1250 Maryland Avenue
1250 MARYLAND AVENUE SW
WASHINGTON, DC 20024

PARTIAL LEVEL 08

SK#08
05 pages
Date: 05-08-2025

1 PARTIAL LEVEL 08 FRAMING PLAN - ZONE A

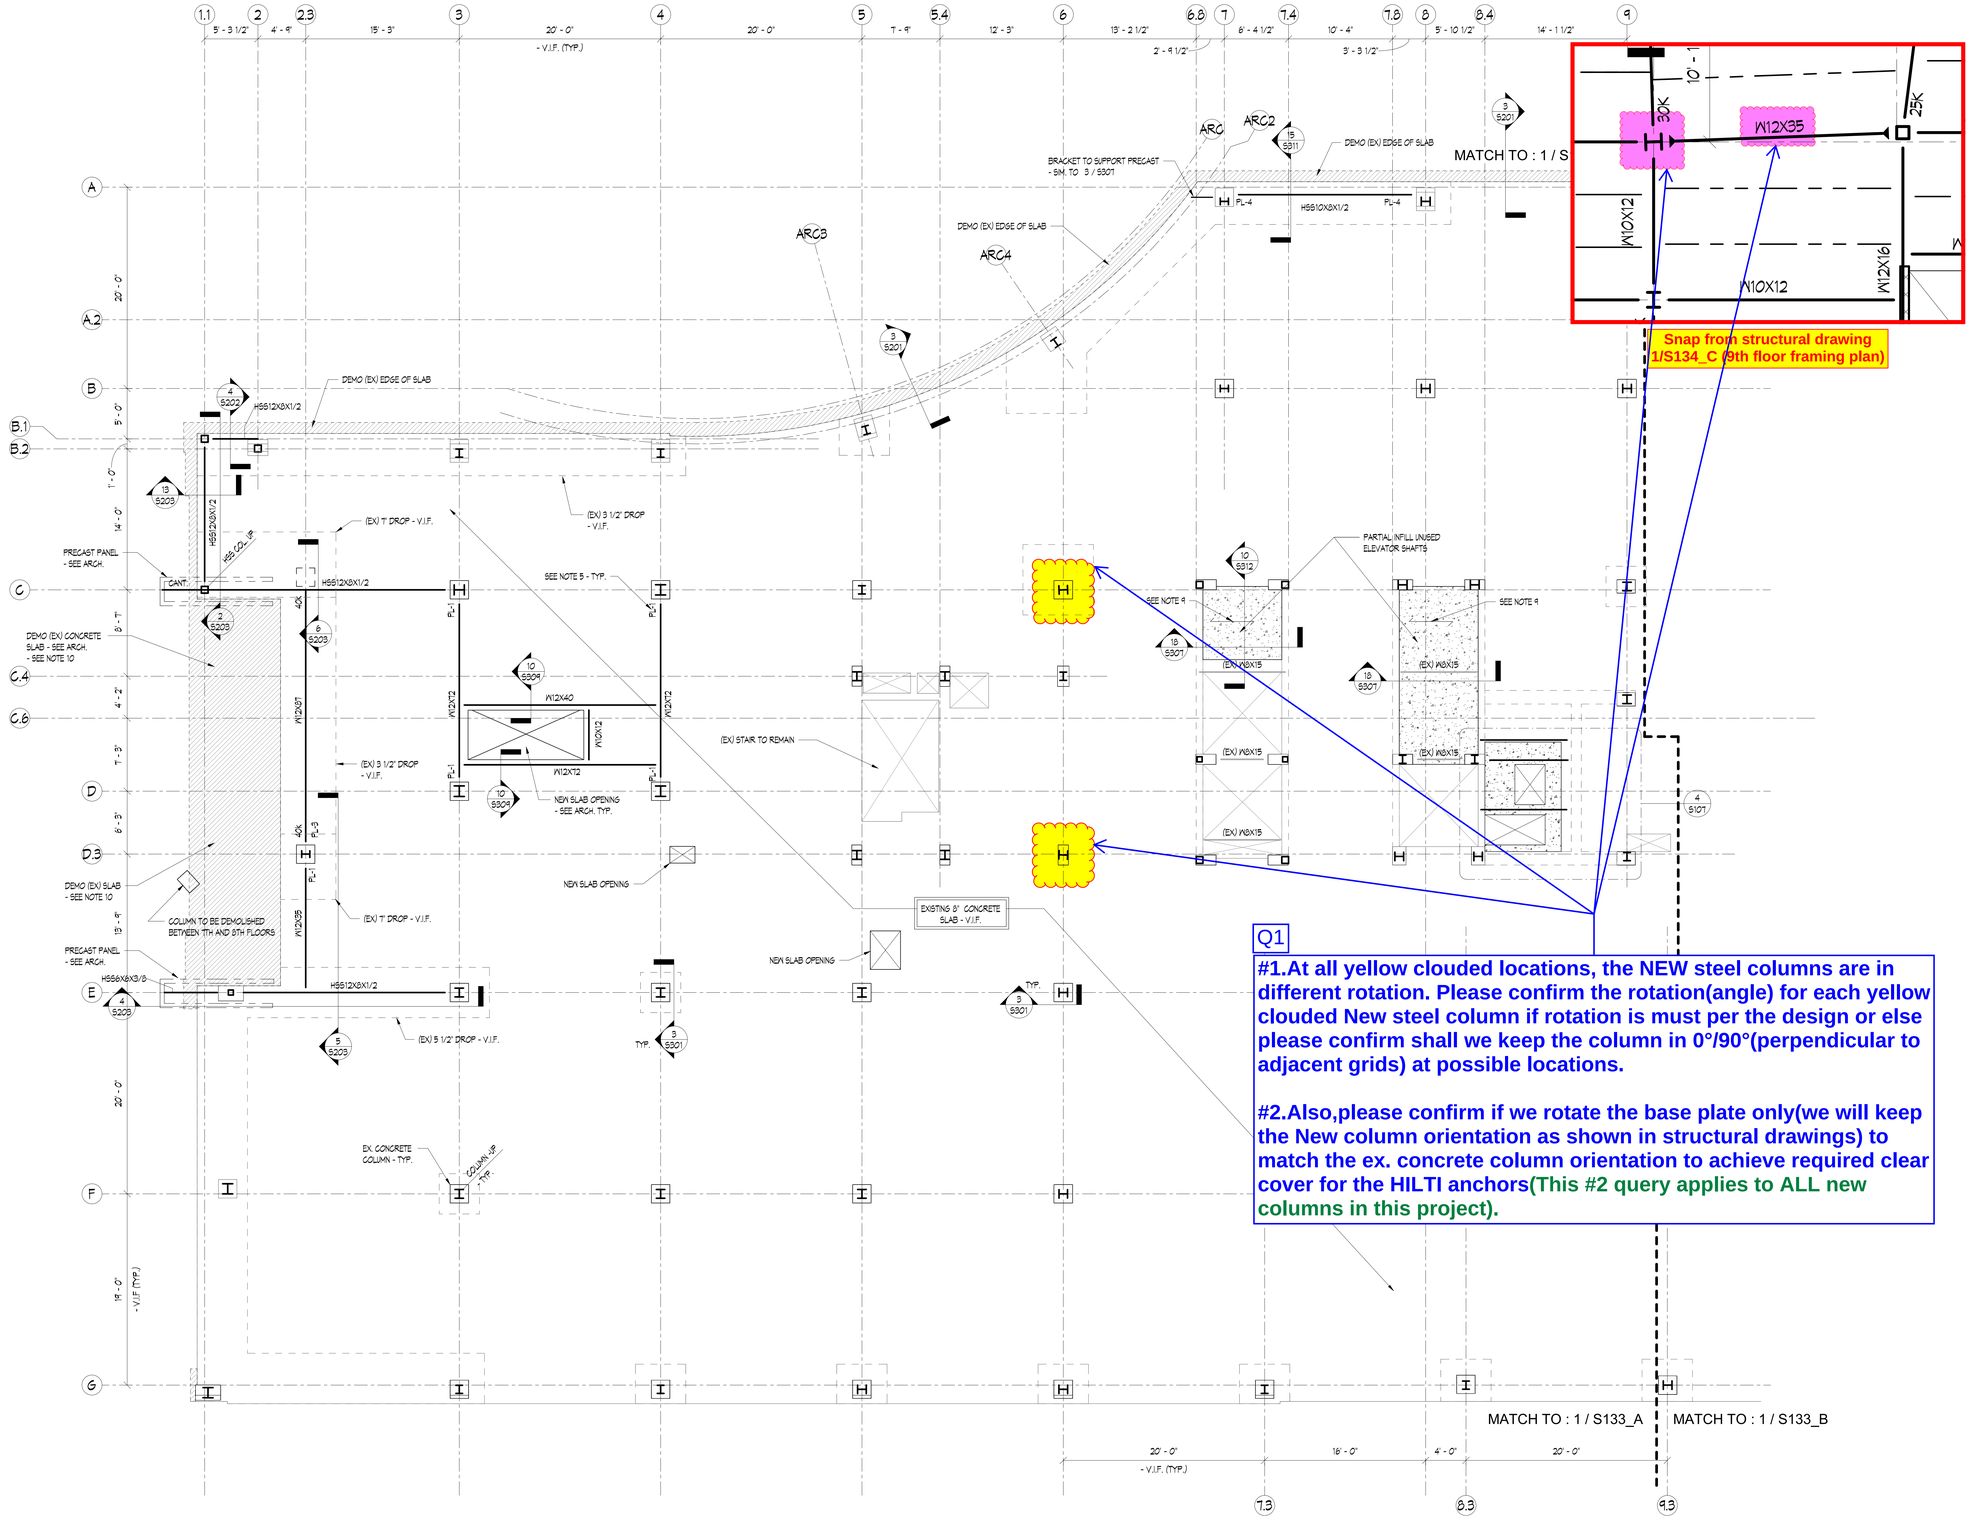
#1.At all yellow clouded locations, the NEW steel columns are in different rotation. Please confirm the rotation(angle) for each yellow clouded New steel column if rotation is must per the design or else please confirm shall we keep the column in 0°/90°(perpendicular to adjacent grids) at possible locations.

#2.Also,please confirm if we rotate the base plate only(we will keep the New column orientation as shown in structural drawings) to match the ex. concrete column orientation to achieve required clear cover for the HILTI anchors(This #2 query applies to ALL new columns in this project).

All yellow clouded column location (See page#1 thru #6) seems to have their column orientation rotated. So, kindly provide the required rotation angle for columns if the rotation is required per structural design.

We intend to follow all yellow clouded columns (See page#1 thru #6) orientation to match with structural beam framing condition at 9th level and above levels (See magenta clouded location for your reference). Please confirm.

Also,
We intend to align the orientation of the new steel column base plates with that of the existing concrete columns to ensure consistency and clear cover for the hilti anchors. Please confirm is it acceptable. (Typical at all new column locations)
